SUBJECT: POTENTIAL RELAY WIRING IMPROVEMENT

Number: 15-13
Product: Cubers
Date Issued: December 15, 2015
From: Technical Service

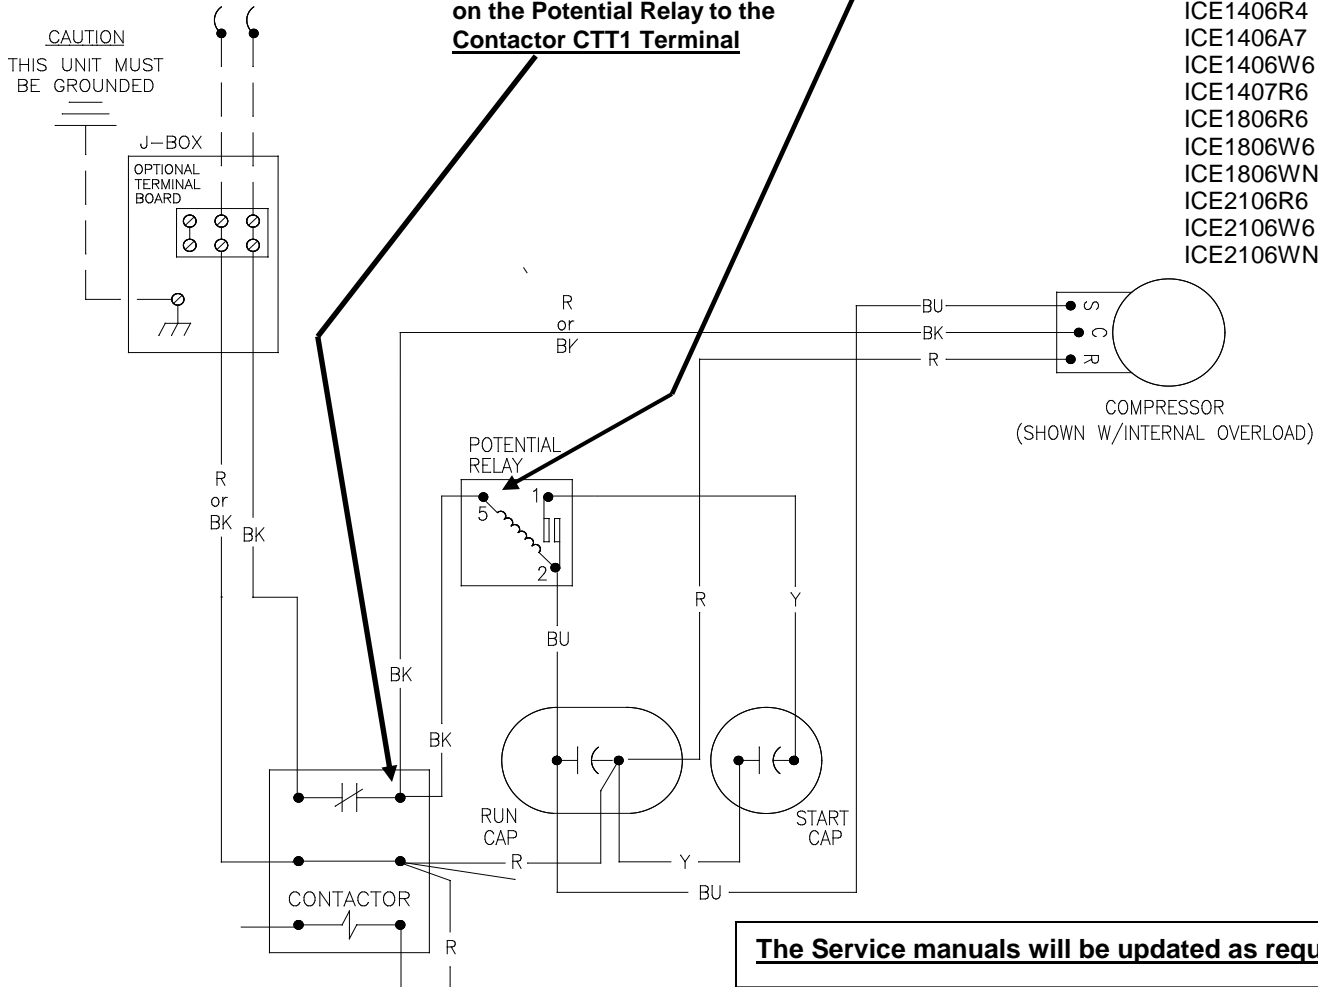
The Compressor wire, either Red or Black was relocated from Terminal 5 on the Potential Relay to the Contactor CTT1 Terminal
